S.I. No. M20-44A Date: 4-24-80

RUDDER AND ELEVATOR AFT BELLCRANK MODIFICATION

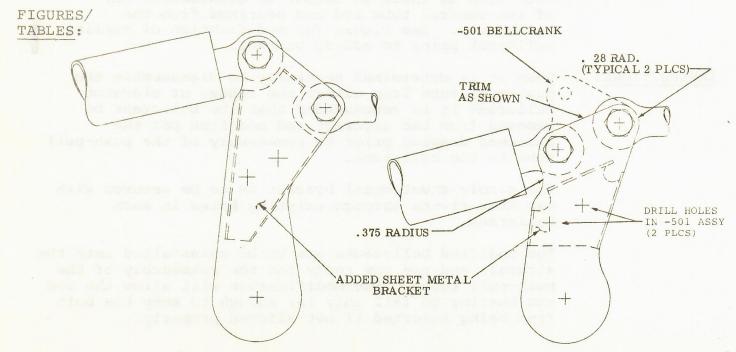
The possibility exists that the rod end bearings on the end of the rudder and elevator push-pull tubes can be attached to the subject bellcranks, P/N 913031-() (Elevator), and P/N 913030-() (Rudder), and not be assembled properly. The rod end bearing can fall below the bolt holes in the bellcrank and the bolt inserted and torqued. The rod end bearing could be clamped between the bellcrank side plates and allow the elevator or rudder normal movement as long as no extreme air loads are encountered.

It is recommended that the bellcranks be updated to the 913030-503 and 913031-503 configurations at such time as there is reason to disassemble any of the control tube rod end bearings from the bellcranks. See Figure for modification of earlier bellcrank prior to adding bracket.

The simple sheet metal bracket is to be secured with two Avex rivets through existing holes in each bellcrank.

The modified bellcranks are to be reinstalled into the aircraft and are now ready for the reassembly of the push-pull tubes. The modification will allow the rod end bearing to fall only far enough to keep the bolt from being inserted if not aligned properly.

Reidentify each bellcrank after modification to XXXXX-503 part numbers and make entry into Aircraft Log Book when S.I. has been complied with.
